AMERICA'S NUCLEAR SOLUTION

July 20, 2016

Subject: Supplemental Information to Support a License Application for a Consolidated Interim Storage Facility for Spent Nuclear Fuel in Andrews, Texas

WCS is providing in Attachment 1 responses to RSIs that were completed by July 20, 2016.

Figure 2-25
Project Location - Road Base

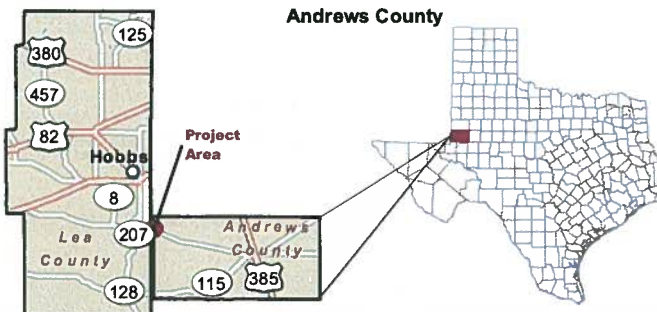
- There is reference of the closest population centers being Andrews, Texas and Eunice, New Mexico, and other nearby population centers in the ER. However, the application does not provide the details of population numbers for clarity and perception for the size of population.

Population centers (more than 25,000 persons) and communities (places less than 25,000 persons) are shown below with distance from the site and 2010 census population (see **Figure 2-25**):

Population centers (more than 25,000 persons) and communities (places less than 25,000 persons) are shown below with distance from the site and 2010 census population (see Figure 2-25):
